# UNITED STATES PATENT AND TRADEMARK OFFICE

APPLICATION NO.	FILING DATE	FIRST NAMED INVENTOR	ATTORNEY DOCKET NO.	CONFIRMATION NO.
10/506,361	05/16/2005	Erwin Weh	JFIE5.004APC	1080

**Office Action Summary**

### **DETAILED ACTION**

# ATTACHMENT A

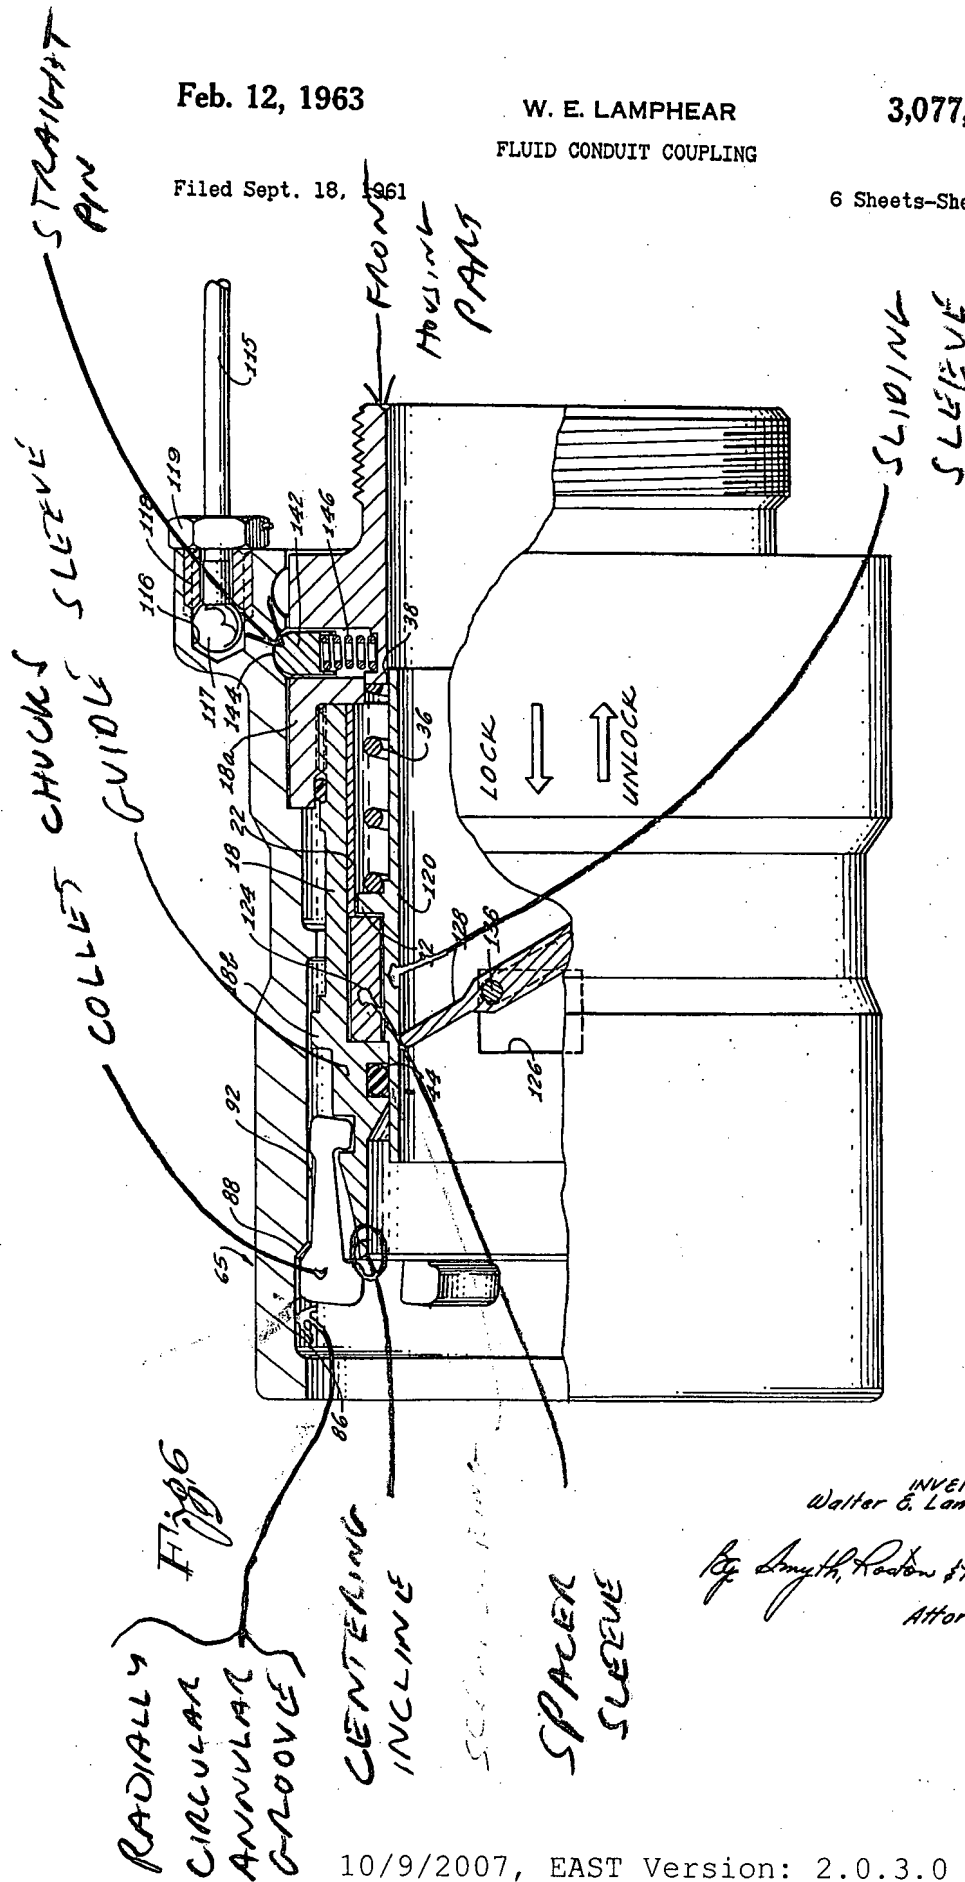
14. In regard to claim 1, Lamphear discloses in Figures 4 and 6, see Attachments A, B, and C, a connection coupling comprising;

a sliding sleeve (as observed in Figure 6, see Attachment A) for locking collet chucks via a connection nipple;

a guide sleeve (as observed in Figure 6, see Attachment A) with longitudinal grooves (as observed in Figure 6, see Attachment A, and column 4, lines 45-51) in which the collet chucks are guided; and

a spacer sleeve (as observed in Figure 6, see Attachment A), at least a portion of the spacer sleeve being disposed between the sliding sleeve and the collet chucks (as observed in Figure 6, see Attachment C, the spacer sleeve is both radially and in a direct line between the sliding sleeve and the collet chucks) such that the collet chucks do not directly contact the sliding sleeve.

15. In regard to claim 3, Lamphear further discloses that the collet chucks are inserted into the longitudinal grooves (as indicated by collet chucks presence in the longitudinal grooves of invention of Lamphear as observed in Figure 6, see Attachment A, they are inserted).

16. In regard to claim 4, Lamphear further discloses that the guide sleeve comprises a centering incline at its front end (as observed in Figure 6, see Attachment A).

17. In regard to claim 5, Lamphear further discloses a radially circular annular groove (as observed in Figure 6, see Attachment A) for receiving the radially outer ends of the outwardly spread collet chucks arranged radially outside of the guide sleeve.

# ATTACHMENT B

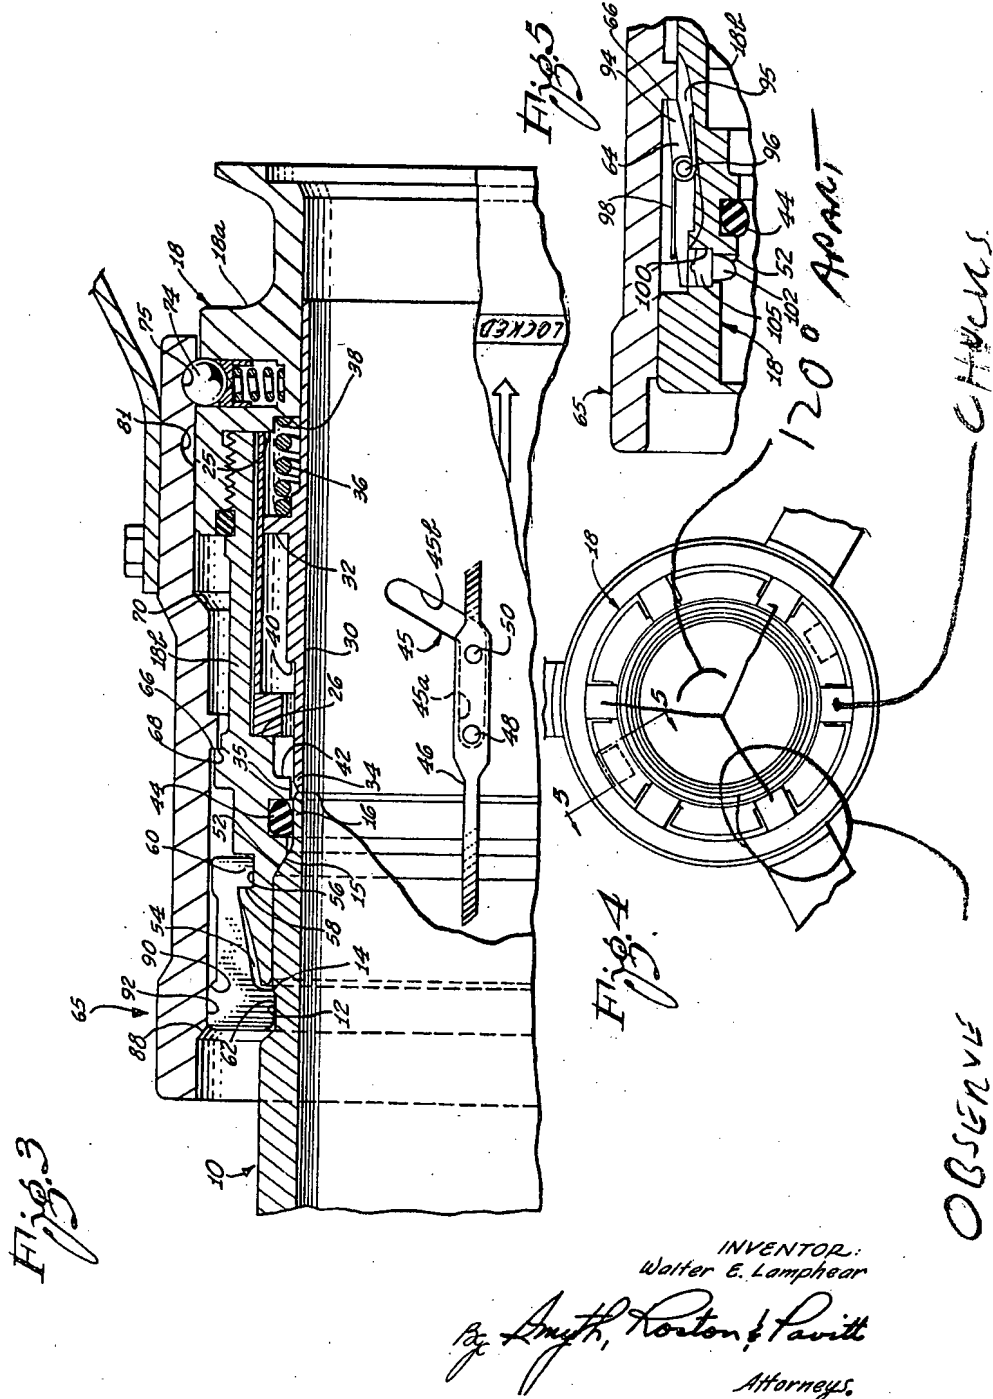
19. In regard to claim 9, Lamphear further discloses three collet chucks and three longitudinal grooves provided in a 120° division in the guide sleeve (as observed in Figure 4, see Attachment B, and column 4, lines 45-51).

Fig. 6

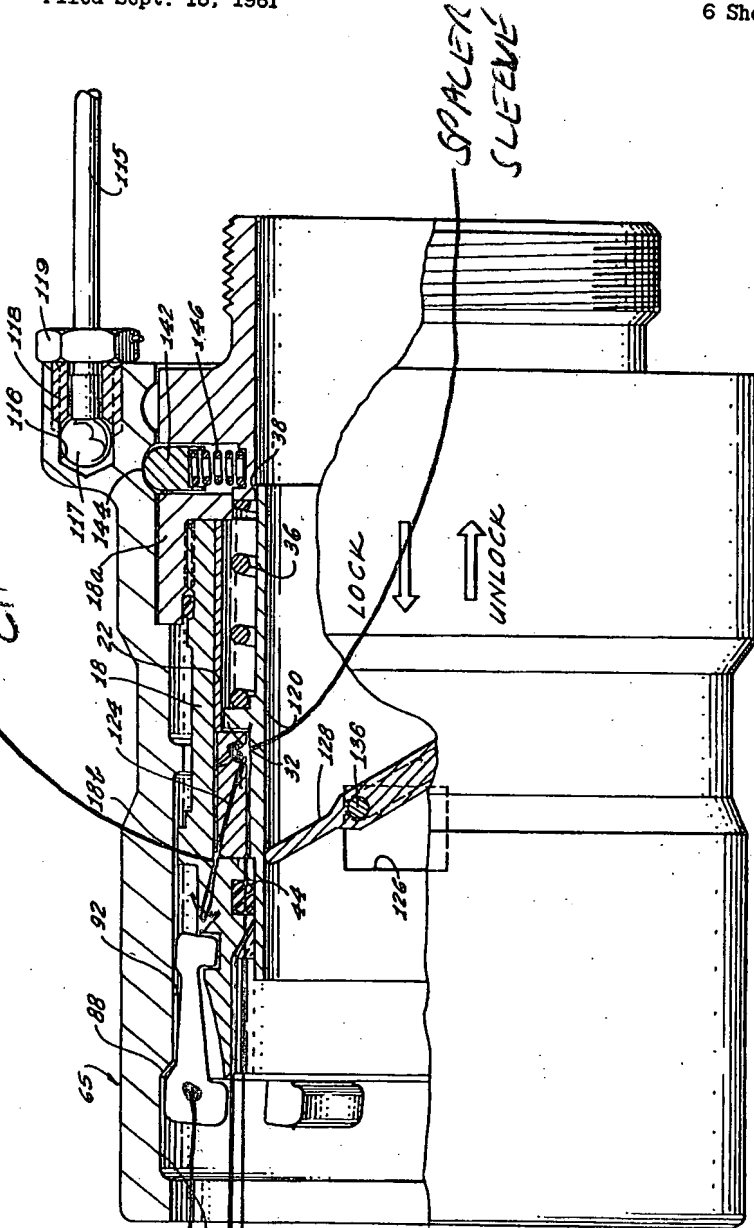
SPACER IN-LINE BETWEEN  
CHUCKS AND SLIDING SLEEVE

SPACER  
RADIALY  
BETWEEN  
CHUCKS AND  
SLIDING  
SLEEVE
